E-101 — ELECTRICAL POWER PLAN

Brightline MEP Consultants — Panels, Circuiting & Egress Lighting

Brightline MEP Consultants — Electrical License No. EE-2025-0633	
Riverbend Family Dental Clinic — Tenant 4400 W. Diversey Ave., Suite 100, Chicago, IL 60639 City of Chicago — Department of Buildings Permit No. BLD2026-04471 Proj. No. 25-0138	
Electrical Plan A066/1526/1526-01 Drawn: J.T. Checked: R.H. Date: 04/11/2026	E-101 Rev A

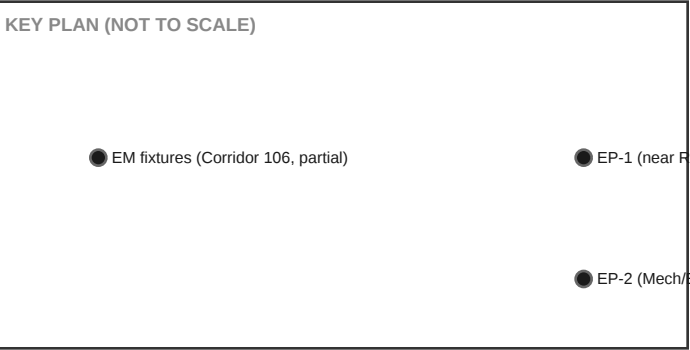
- Panel EP-1 (Waiting/Office area, 120/208V, 42-circuit) requires a dedicated equipment clearance in front of the panel. This clearance zone is shown landing at the same stretch of Corridor 106 where the Restroom door (104) is shown swinging into the corridor on A-101 -- coordinate with the architect, since the door swing as drawn overlaps the panel's required clear working space.

- Panel EP-2 (Mech/Elec Room 105, 120/208V, 30-circuit) is shown with 30" of dedicated clear working space in front of it. The minimum clear working space required for a panel at this voltage-to-ground condition is 36"; the 30" shown does not meet that minimum on its own, before even accounting for other equipment in the room.

- The plumbing plan (P-101) shows water heater WH-1 set 18" from the same wall as Panel EP-2, which further reduces the usable clear floor space in front of EP-2 to approximately 18" -- coordinate panel and water heater locations with the plumbing engineer.

- Emergency lighting fixtures (tagged EM) are provided along Corridor 106 to serve the egress path shown on the architectural life safety plan (A-102). As currently laid out, these fixtures are spaced along the corridor only as far as Grid 2 and do not appear to continue the remaining distance west to the exit at Vestibule 101 -- verify that fixture spacing provides continuous coverage along the full egress path shown on A-102, not just the portion nearest the operatories.

- The new electrical service duct bank routes underground from the utility connection to the main distribution equipment; see C-101 for the site routing. C-101 notes a crossing between this duct bank and the new domestic water service with no separation called out -- coordinate the required horizontal and vertical clearance between these utilities with the civil engineer.
